SRC 2020-118
Change signals 81 and 82 to
3S12"FYRA (red ball, yellow ball,
flashing yellow right arrow)
- A.Lam 2020-12-09

6/03	AS-BUILT	DW	SL	REFERENCE INFORMATION & FILE NO. OF SURVEYS		BUREAU OF ENGINEERING DEPARTMENT OF PUBLIC WORKS CITY AND COUNTY OF SAN FRANCISCO		DESIGNED: DATE:	APPROVED	SCALE:	OAK AND FELL STREETS TRAFFIC SIGNAL UPGRADE PIERCE AND OAK STREETS	SPECIFICATION NO.	
5/01	CHANGE ORDER #3 MSF - HOMERUN	JP	SL	JM/DVS				2/00	SECTION MANAGER	DATE:		1" = 10 feet	1660N
3/01	CHANGE ORDER #2	SL	SL	DRAWN: DATE:				JS	2/00	DIVISION MANAGER		DATE:	E-13.0
2/00	ISSUED FOR BID	JM	NKS	CHECKED: DATE:				NKS	2/00	CITY ENGINEER		DATE:	74167
TABLE OF REVISIONS				CHECK WITH TRACING TO SEE IF YOU HAVE LATEST REVISION				SHEET OF SHEETS		26 OF 89	REV. NO.		
											0

OAK AND FELL STREETS
TRAFFIC SIGNAL UPGRADE
PIERCE AND OAK STREETS SCHEDULES

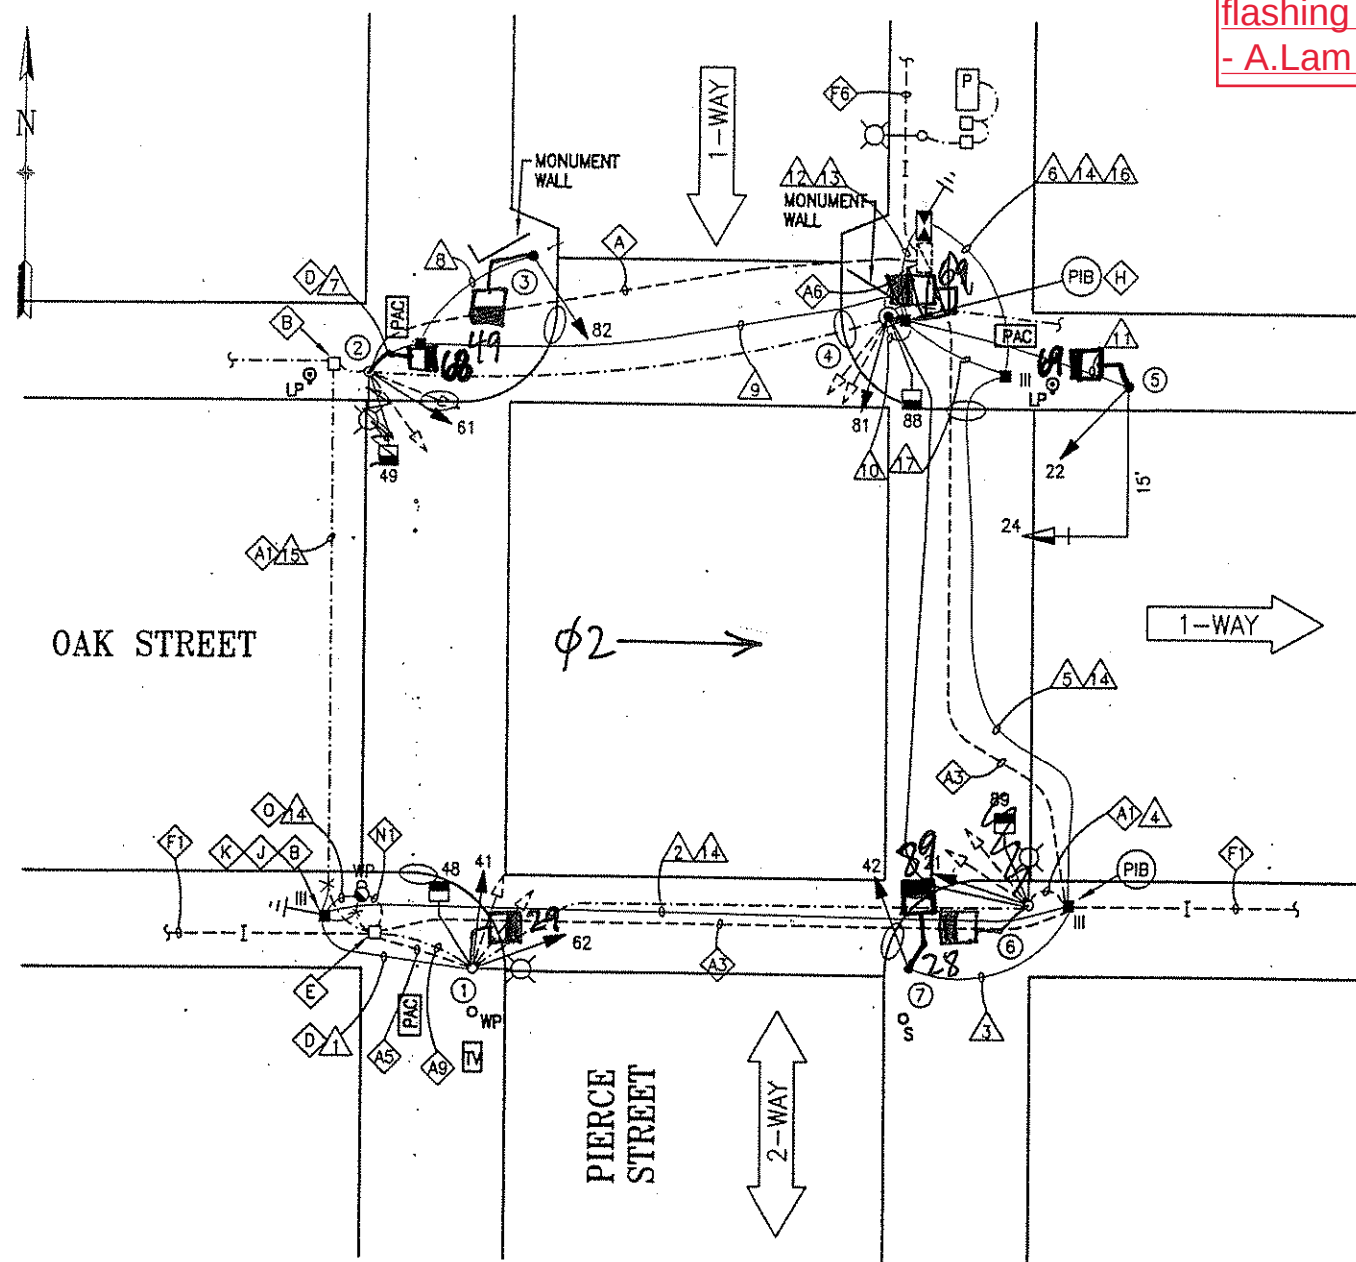
Modified per SRC 2020-118 to be 12" red ball, yellow ball, and flashing yellow right arrow
